PRODUCT CHANGE NOTIFICATION

PRECISION POTENTIOMETERS

Marking Process for Select Bourns® Precision Potentiometers

Change from Ink Marking to Laser Etching

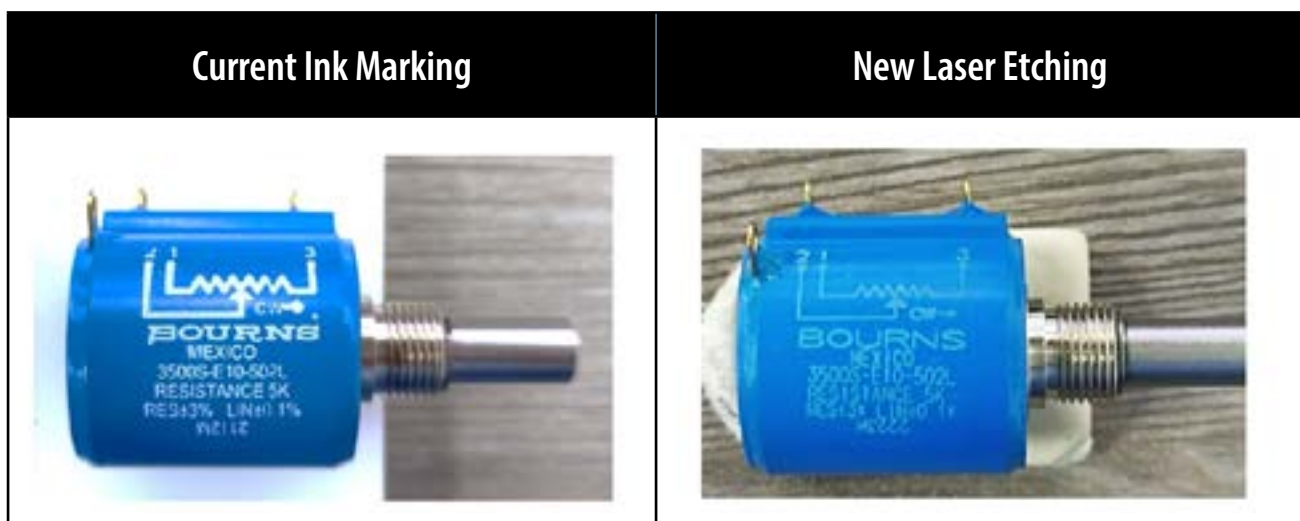
Riverside, California - December 19, 2023 – In the spirit of continuous improvement and environmental awareness, effective immediately, Bourns will change the marking process for select [Precision Potentiometers](#) from stamped ink marking to laser etching to increase the identification and traceability of some of our products. A list of affected part numbers is included on the following page.

The current product marking on the Precision Potentiometers uses a white marking over a blue or black background. The new marking will be laser etched over the blue or black background. The change to a laser etching process will have no impact on the fit or function of the product. The form of the product will change slightly due to the transparent laser marking on the outside of the product and the manufacturing process will change due to the use of a different marking process step. The quality and reliability of the marking on the product should be improved as a result of the process change. Quality test data is available upon request.
